Council Reference: DA09/0830.16
Your Reference: MP07/0179.06

MP07_0179 Mod 6 - Response to invitation for comments

Thank you for the opportunity to comment on MP07_0179 Modification No 6.

Figure 1: Approved Section Plan

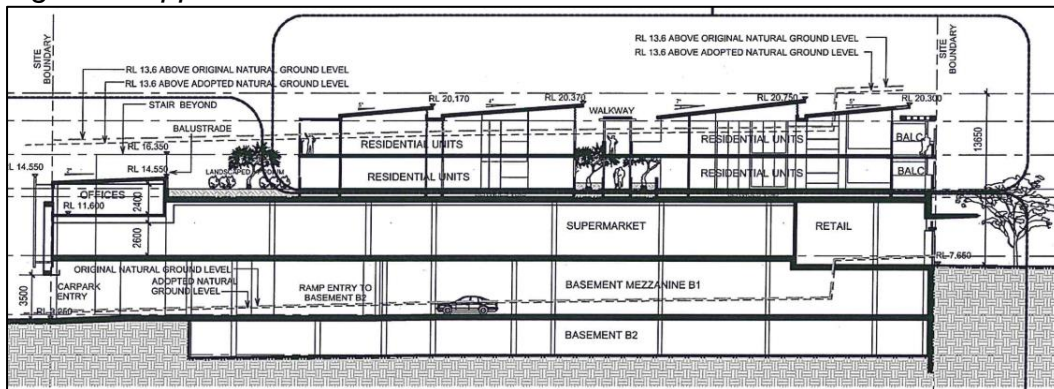
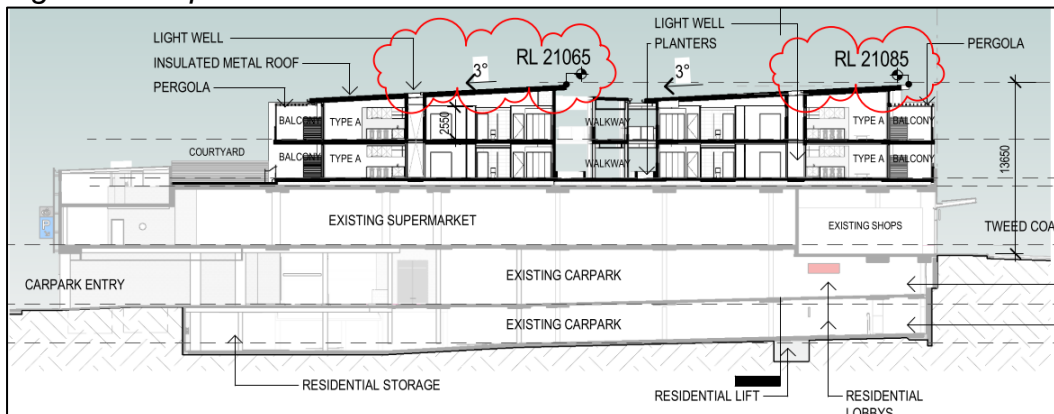
While the height of the elevation to Tweed Coast Road is increasing, the maximum building height of the building is maintained. However Council has concerns in relation to the proposed changes to the roof profile. The modulated roof design as approved is more consistent with the roof lines controls for Bogangar/Cabarita in the Development Control Plan 2008 – Section B19. The current proposal is more monotonous and will contribute little to the streetscape, particularly when viewed from Hastings Road.

- Minor changes to skylights; and
- The form has been refined to provide a single pitched roof over each unit. The roof level has increased in some areas, though remains under the approved maximum limit.

The stepped roof profile of the approved development is visually more attractive than what is proposed and more successfully breaks up the bulk of the development. The approved roof plan is also consistent with the roof line controls in the Development Control Plan 2008 (Section B19 – Bogangar/Cabarita beach Locality Plan):

While it is recognised that the driver for the change in the roof profile appears to result from the introduction of the skylights (to provide additional light to internal areas), the upper level will be highly visible from Hastings Road.

The change in the roof profile, will also result in an increase in the overall height of the building. The maximum height identified for the site in the Tweed Local Environmental Plan 2014 (which was adopted after the approval of this application) is 13.6m. While the maximum height in the approved plans (21.250m RL) is respected, the extent of the building at this maximum height is increased. As can be seen from the approved and proposed sections and elevations in Attachment 1.

Figure 15 – Cross section of landscaped podium (Source: Environmental Assessment).

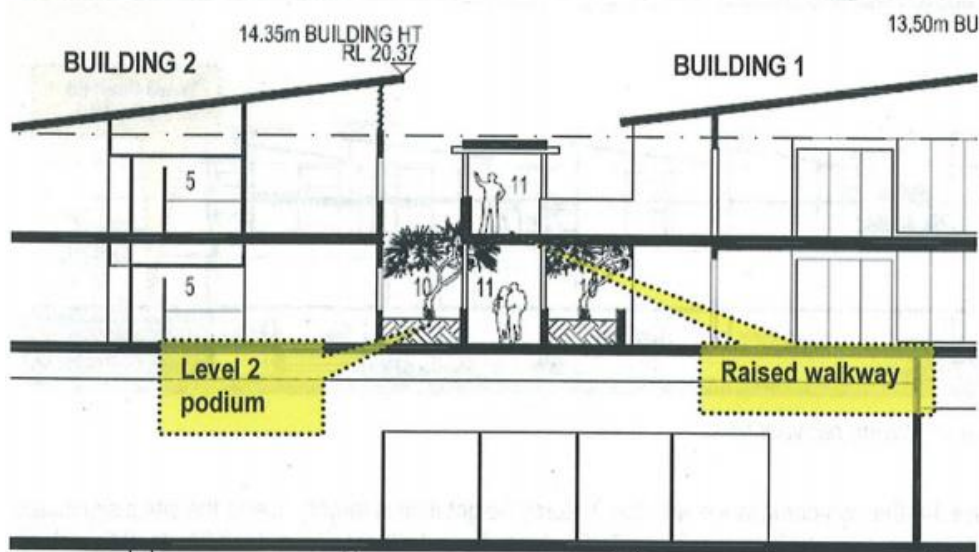
Above the level 2 communal area is a raised walkway servicing the entries to level 3 dwellings. The Department's concerns regarding the amenity problems associated with the landscape podium primarily relate to the proposed minimal separation distances between Building 1 from Building 2, and the overall length of these apartments. In particular, the lack of sunlight penetration to the level 2 area is considered poor design as it will prevent habitable rooms facing the podium from receiving natural sunlight. Further, the minimal solar access to the lower podium raises questions regarding the viability of plant growth in the absence of sufficient sunlight penetration.

The proponent responded to the issues raised by introducing visual screening devices to assist with separating the dwelling entries within the podium area. The proponent's PPR outlined that the inclusion of the screening provided both visual and acoustic privacy along with a further level of separation between habitable rooms. The PPR also noted that a further 192m² of landscaping has been added to inaccessible roof areas of level 2. These introduced screening devices and the additional landscaping appears to be an attempt by the proponent to address the guidelines set by the Residential Flat Design Code (the Code) which recommends building separation distances of 12m, and open space landscape areas (for mixed use developments) of between 25-30% (Table 2). The additional landscaping to the roof areas of the amended proposal is considered to be an improved outcome as it will allow for better vegetation screening to properties west of the site. However, the amendments have not increased the overall size of open space share areas accessible to occupants of the apartments. While the introduced screening attempts to improve the general amenity of the podium area, the minimal size of this shared common area and its lack of solar access remains of concern. Therefore, in order to achieve an acceptable level of residential amenity for future residents of the development and enlarge the landscaped podium, a condition of approval requiring the overall length of some apartments to be reduced has been recommended.

Figure 7: View of development from Hastings Road (source: Google Instant street view)

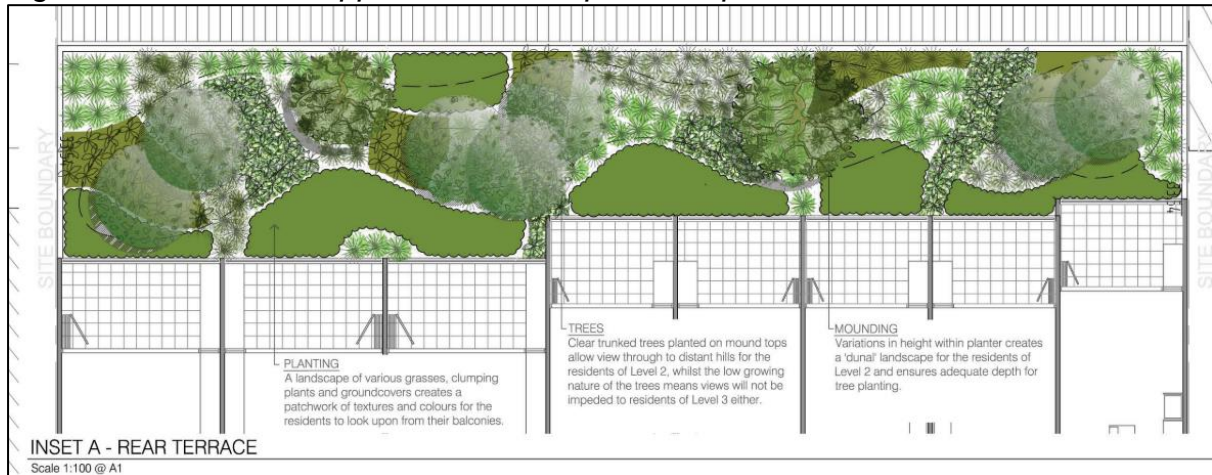
- The balconies of Units 1 - 8 and Units 20 - 27 will be located between 15.8m to 17.2m from the Hasting Road boundary. While no updated photomontages or 3D renders of the proposal have been submitted with this application it is not considered that the visual impact from street level will be significant.

- The applicant has also not provided any analysis of the impact on view sharing, other than submitting that view sharing will not be impacted. However, having regard to the approved development and the height of the adjoining balconies at 49 Tweed Coast Road (Waterbreak Views), it is not apparent that there would be any additional view loss.
